Product Change Notification

TE Connectivity

Product Change Notification: P-22-022403

HVP800 2P HEADER ASSY

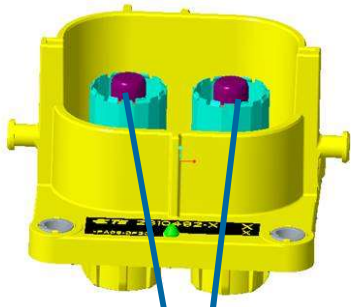
Before Change

P/N: 0/3-2322122-1/2

Terminal

Housing

# 产品对比 Part Comparison

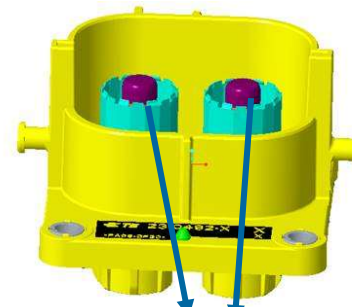
After Change

P/N: 8/5-2355198-1/2

Optimized Terminal

Optimized Housing

端子和塑壳形状有变，成品外部尺寸没有变化，性能没有变化  
Only terminal and housing changed, but no other change, no performance change.

# 产品对比 Part Comparison

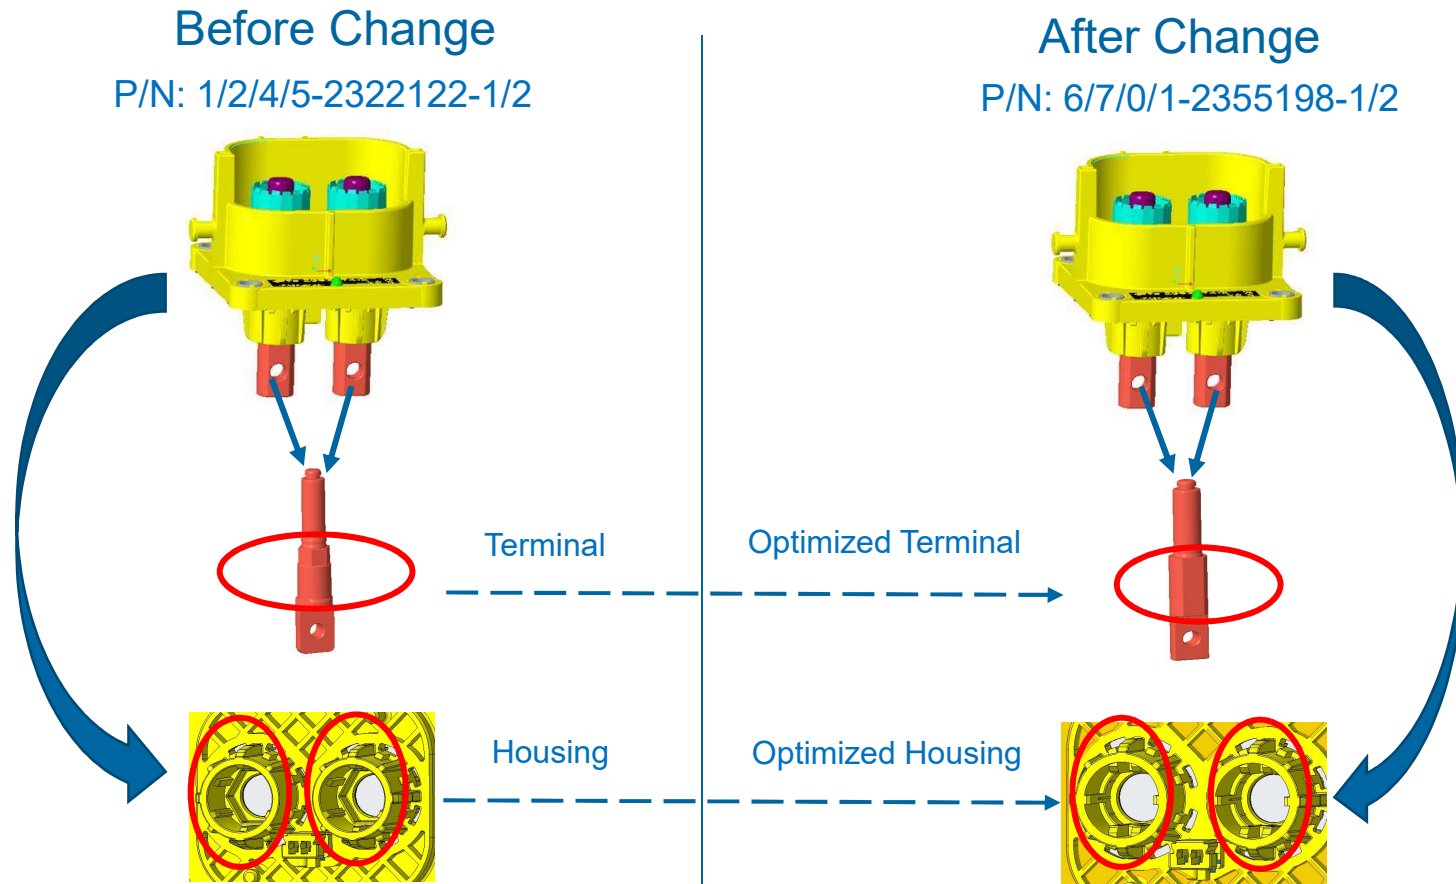
端子和塑壳形状有变，成品外部尺寸没有变化，性能没有变化  
Only terminal and housing changed, but no other change, no performance change.
